2004 - 2009 Cadillac XLR XLR-V: Recall Notice: #15643: Special Coverage Adjustment - Airbag Light On

Subject: 15643 — Special Coverage
Adjustment – Airbag Light On

Models: 2004 - 2009 Cadillac XLR
2005 - 2013 Chevrolet Corvette

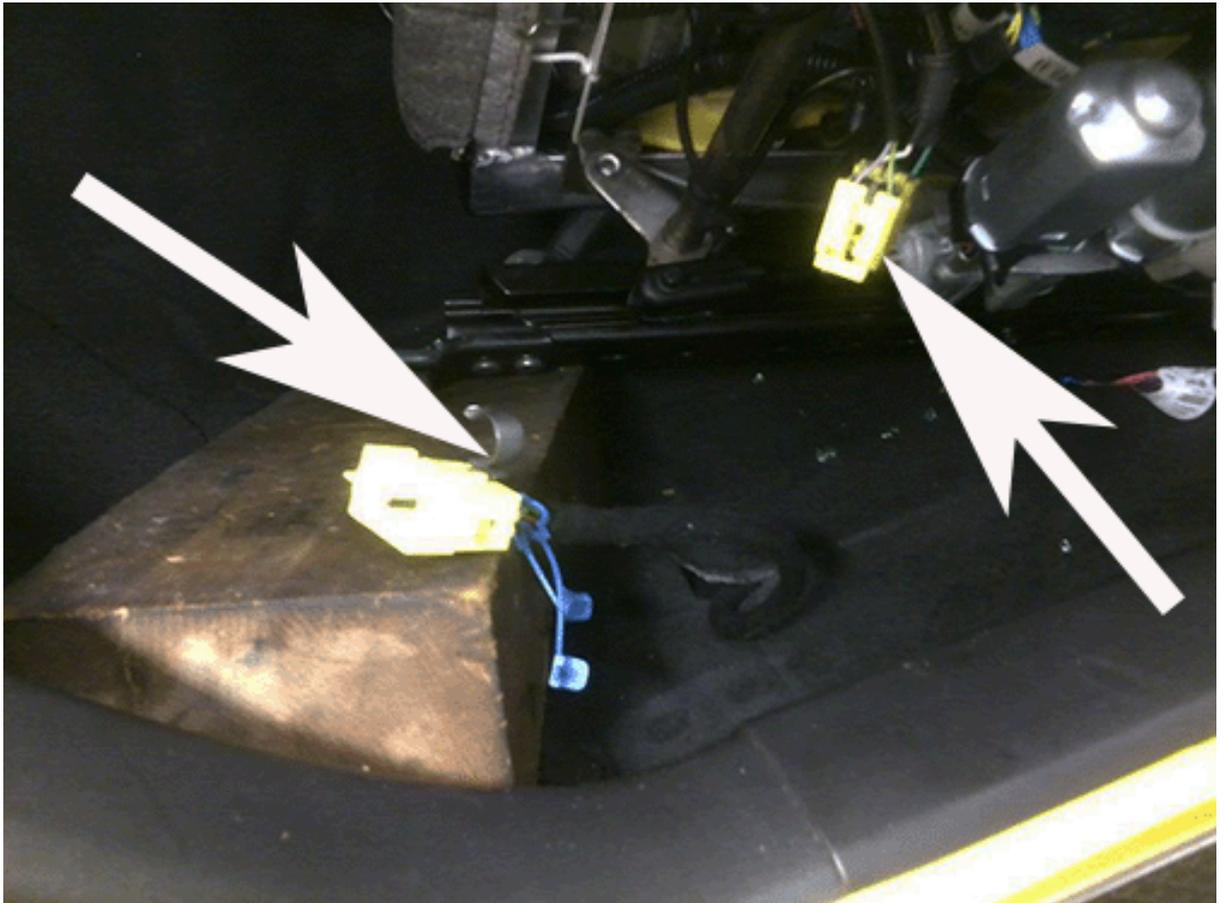
Use the following steps to remove the existing yellow SIR seat to vehicle connector and wire the seat harness to the vehicle using splice clips, solder and heat shrink.

1. Remove the four seat mounting nuts from the effected seat. Do not remove the seat from the vehicle. Refer to *Driver or Passenger Seat Removal and Installation* in SI. It is not necessary to disconnect the seatbelt from the seat.
2. Move the seat to the center position on the seat track.
3. Disable the Supplemental Inflatable Restraints (SIR) system. Refer to *SIR Disabling and Enabling* in SI.

1. Using wood blocks or similar material, tilt and support the seat in the vehicle as shown.

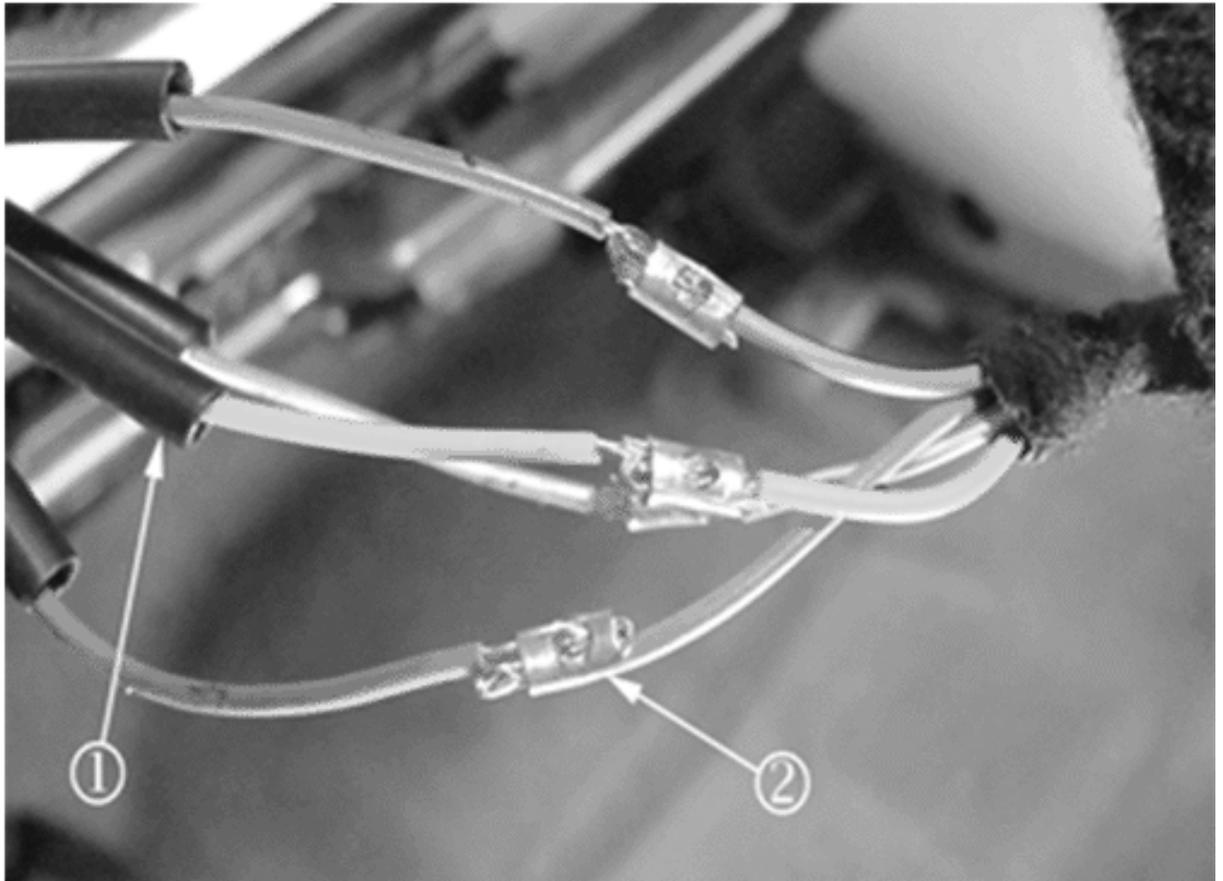
Note: Before removing the yellow connector from the seat and body harness, note the wire colors of the seat and body harness. Some wire pairs may be a slightly different color. Some wire pairs may have different colors. Ensure the wires are matched **BEFORE** splicing the wires of the seat and body harness together. Use the cutoff connector as a wire color template. **BEFORE** removing the connector from the harness, mark or identify wire pairs of similar color using a pen and tape to ensure the correct wires are spliced together.

1. Make a list of how the wires relate from the body side harness to the seat harness. It critical that the wire pairs

are identified correctly to avoid splicing incorrect wire pairs. *THE WIRE COLORS ON THE BODY SIDE HARNESS AND THE SEAT SIDE HARNESS ARE NOT THE SAME.*

2. Using side cutters, cut the four wires on the body and seat harness as close the connector as possible.

1. Strip off approximately 13 mm (1/2 in) of insulation from the wiring ends. Fold the wires.

1. Add one approximate 38 mm (1.5 in) section of heat shrink tube to each of the four wires (1).
2. Join the four wires together. Use the wire color list created above to determine correct wire position.
3. Crimp a splice clip over the joined wires using Special Tool J-38125-8, nest F. Verify the crimp quality. Repeat this crimp process on all four wire connections (2).

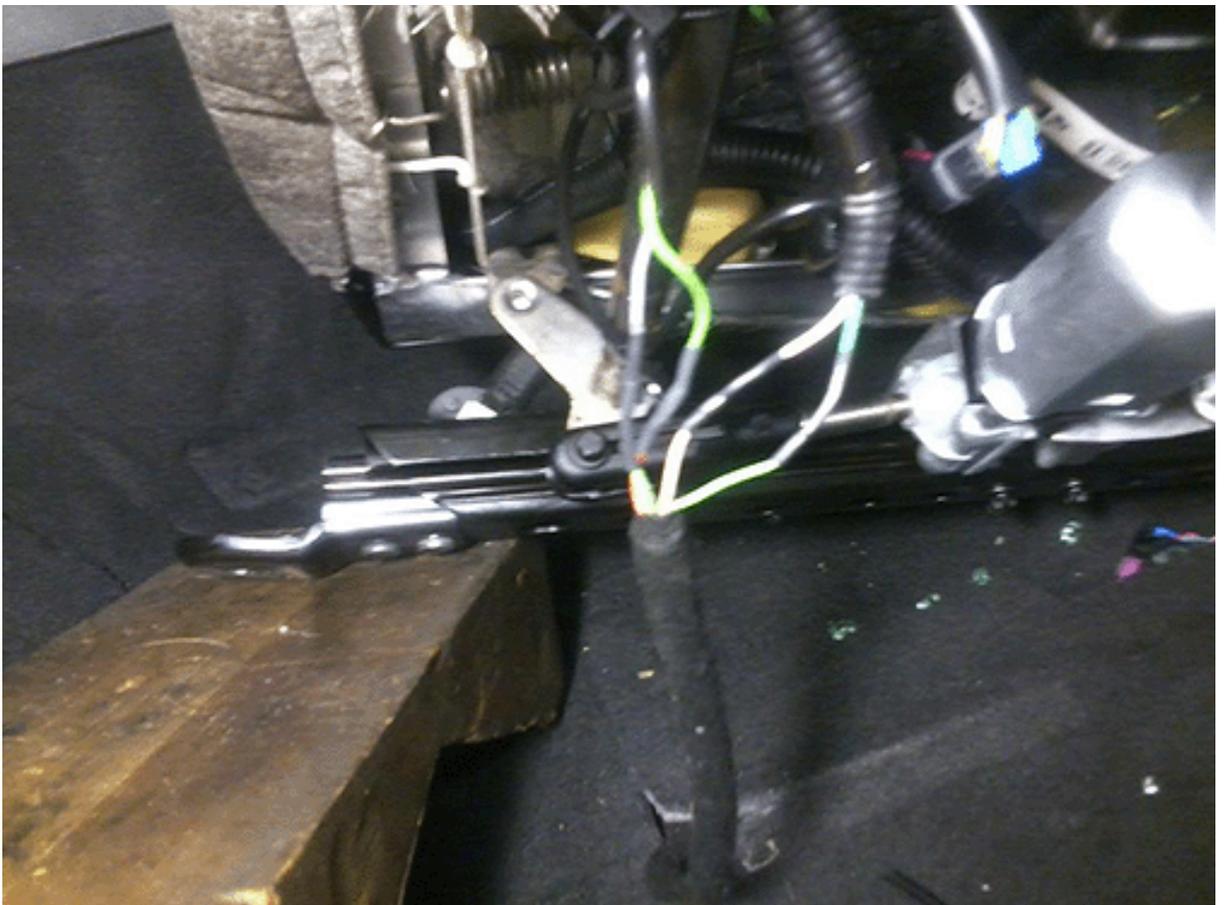
Note: Keep the heat shrink tube below the splice when soldering the splice to ensure that the heat shrink is not prematurely shrunk and closed down over the wire or splice area due to the heat from the soldering iron.

1. Solder all four crimp and splice clips using the Ultratorch, part number J-38125-5, or another butane fueled soldering iron.

1. Center the heat shrink tube over all four splices and shrink/seal the heat shrink tube securely over the splice crimp and insulated wires.

1. Wrap woven polyester electrical tape (PET) or equivalent anti-abrasion tape around the spliced section of both wires. Continue to wrap the harness as shown.

1. Wrap two sections of yellow electrical tape over the polyester electrical tape on both sides of the splice.
